TECHNICAL INFORMATION JDE

Type Coffee Vending Machine	Model 9100	T.I. NO 08 - 2017		
Serial Number 72011867	Subject Standardization of the Touch screen thickness (3 mm)	ISSUED FOR (X)	Action Information	<input checked="" type="checkbox"/>

Touch screen assembly - display thickness **3 mm**

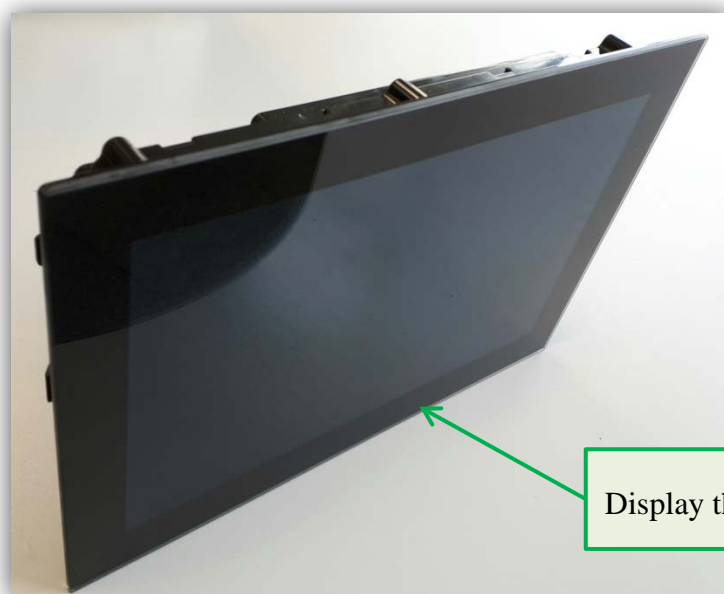
The display **thickness** of the different touch screen versions have been standardized to **3 mm**.

Touch screen assembly - display thickness **2,5 mm**

Spare code: **259783 - It is no longer available**

Machines concerned by modification from S/N 72011867.

Spare code: **260321**

The **standardized** solution (3 mm) is retrofittable.
